To: T10 Technical Committee
 From: Rob Elliott, HP (elliott@hp.com)
 Date: 3 October 2003
 Subject: T10/03-337r0 SPC-3 Third party persistent reservations

Figure 2. Give and take

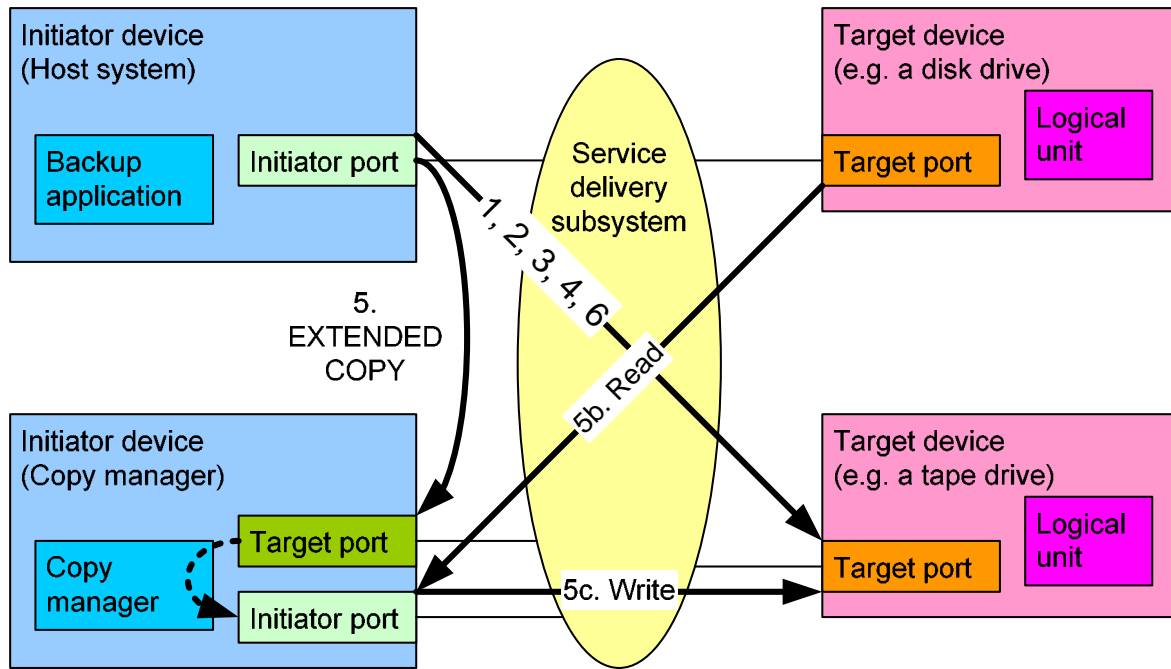
Add GIVE and TAKE bits to the REGISTER service actions to move the reservation.

1. Register self with the destination (e.g. tape drive) with PR OUT/REGISTER
2. Reserve with PR OUT/RESERVE
3. Prepare destination (LOAD, REWIND, etc.)
4. Register copy manager and give reservation with PR OUT/REGISTER
5. Send EXTENDED COPY to copy manager; wait for completion
6. Unregister copy manager and take back reservation with PR OUT/REGISTER

- 5a. Receive EXTENDED COPY command
- 5b. Copy manager reads from one logical unit (e.g. a disk drive)
- 5c. Copy manager writes to the reserved logical unit (e.g. a tape drive)
- 5d. Return status for EXTENDED COPY
